# RFx: 5000014891

# TENDER FOR SUPPLY, INSTALLATION AND COMMISSIONING OF A FIBER OPTIC CABLE NETWORK AT OLKARIA.

Dated: 28th March, 2024

Addendum No.1.

## (a) At Lakeside housing estate

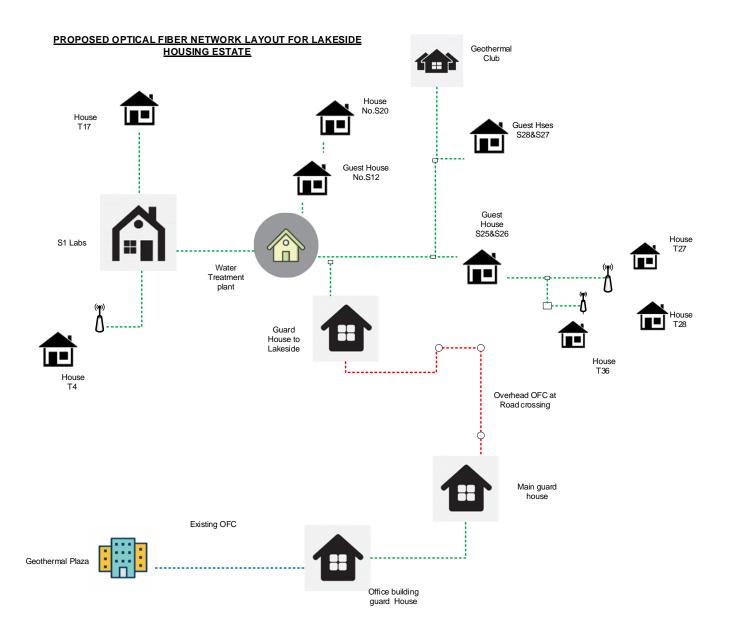
- (i) Supply of materials and underground installation of a 24-Core, armoured Single Mode Optical fiber cable from Guard house to Lake side housing estate to Water treatment plant, and from Water treatment plant to SI Labs, Guest houses S25, S26, S27 & S28, Geothermal club and to outdoor access points to be installed adjacent to House Nos.S20,T36 and T28.In addition, the 24core underground armoured optical fiber cable shall also be installed between S1 Labs to connect outdoor access points to be installed near House Nos.T4 and T17.

- (ii) Supply and installation of 250Meters of an overhead 24-Core Single Mode All Dielectric Self Supporting (ADSS) cable between Office building guard house and Guard house to Lake side housing estate. The cable shall be installed on existing poles across Moi South Lake road between the Main Guard House and Guard House to Lakeside housing estate.

- (iii) Supply and installation of 3No.ADSS cable pole mounting kits complete with accessories for installations in (ii) above.

- (iv) Supply and install approx. suitably sized HDPE pipes, and warnings tape for underground cable installations.
- (v) Fabricate and install Five (5No.) mounting poles for outdoor access points.

- (vi) Supply, installation and configuration of Nine (9No.) indoor access points-2 each for Guest houses S25, S26, S27 & S28, and one for SI Labs.
- (vii) Supply, installation and configuration of Five (5No.) outdoor access points adjacent to House Nos.S20, T36, T28, T4 and T17.

- (viii) Extend 240Vac mains power supply to outdoor access points adjacent to House Nos.S20, T36,T28, T4 and T17.This shall be done using 3-core (L,N& E) 2.5mm sq armoured cable that shall be installed underground.

- (ix)Construction of 7No.standard manholes for Telecommunications installations -internal dimensions not less than 3ft X3ft, 3ft deep, complete with manhole covers.
